## ***Interactive comment on “Characteristics of landslides in unwelded pyroclastic flow deposits, southern Kyushu, Japan” by M. Yamao et al.***

**M. Yamao et al.**

Received and published: 15 January 2016

Fig. 1. new Figure 11

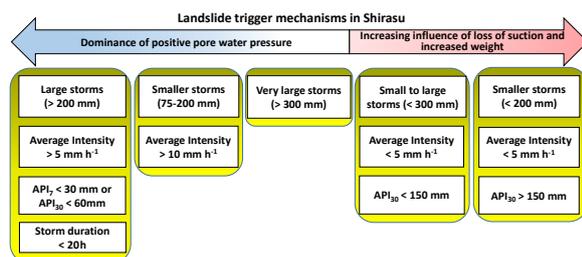
3. The reviewer notes that it was difficult to follow the description of the criteria we suggested for different landslide types because mechanisms of landslide initiation are

involved. We have taken the advice of this reviewer and put together a chart that addresses the empirical criteria (based on our analyses and understanding) that affect the different landslide trigger mechanisms in Shirasu (new Figure 11). While this diagram is quite general, hopefully it is helpful. We retained subsection 4.1 as we added another subsection to the Discussion (for empirical criteria). We now provide a better transition sentence to introduce the rainfall intensity – duration landslide thresholds and related API assessments (section 4.1): “To illustrate the importance of API on certain types of landslides in unwelded pyroclastic flow deposits, we employ typical rainfall intensity – duration threshold analysis.” We have also modified several sentences later in this section to hopefully avoid any further confusion. The last paragraph of Section 4.1 now reads: “While many landslide producing storms plot near the Sidle and Ochiai (2006) threshold, 21 landslides were triggered by events plotting below the threshold (Figure 9). Only two of these 21 events had API30 values < 235 mm and more than half had API30 values > 300 mm. Given this high level of water stored in the porous Shirasu deposits prior to the triggering storms, most of these 21 landslides and some of the events positioned just above the threshold are likely influenced by the combined effects of the accumulated mass of rainfall and the associated loss of matric suction within these deposits.”

[Add new Figure 11 here] Figure 11. Diagram of empirical criteria that affect different landslide triggering mechanisms in Shirasu deposits in southern Kyushu.
